TO :- GAURI KULKARNI

RFI/A/FINISHING/001

dt 11/3/15

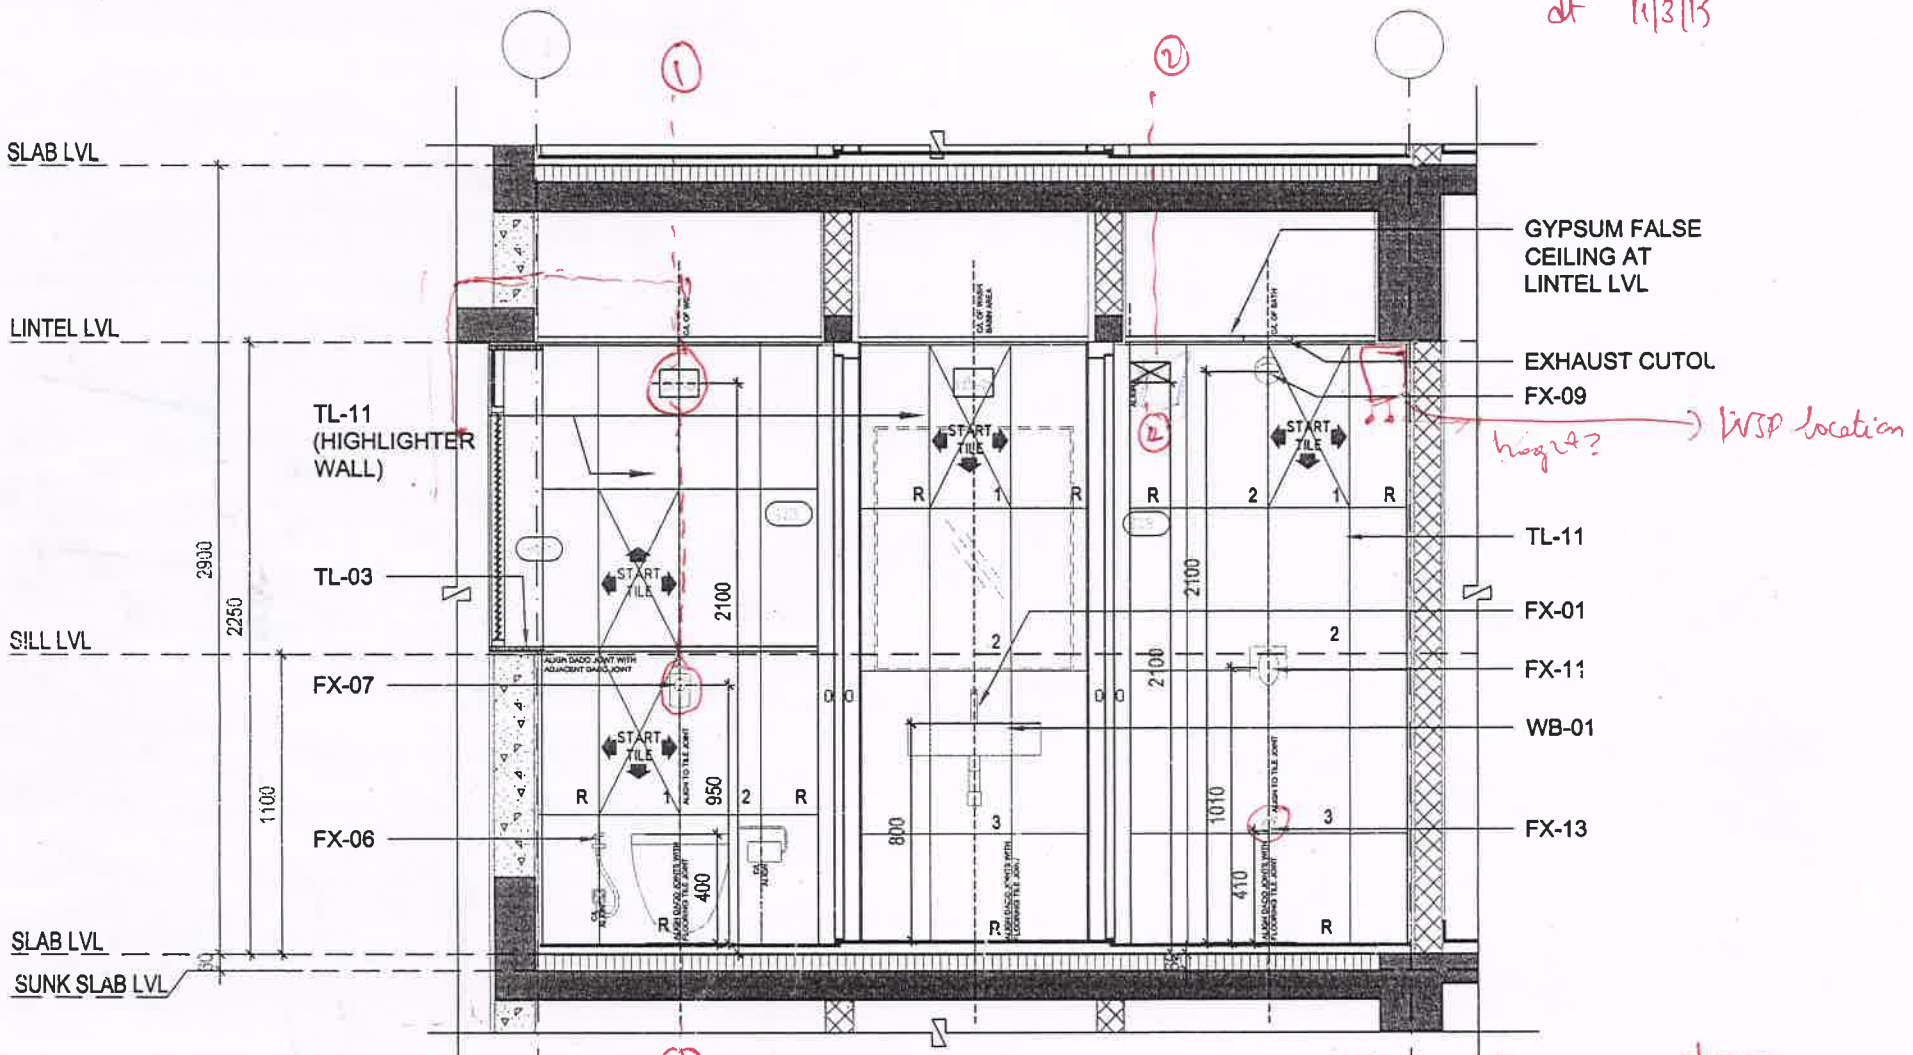
① Plumbing line for flush valve in WC is along ①-①, & same location light point is shown

② Geyser location is shown as marked in above as per WSP Dwg - & KAPL Dwg location of geyser point is along ②-②

③ Height of geyser plumbing line

④ 410mm Height of spout is too small (Bucket Height is much more). Can we change to 510mm?
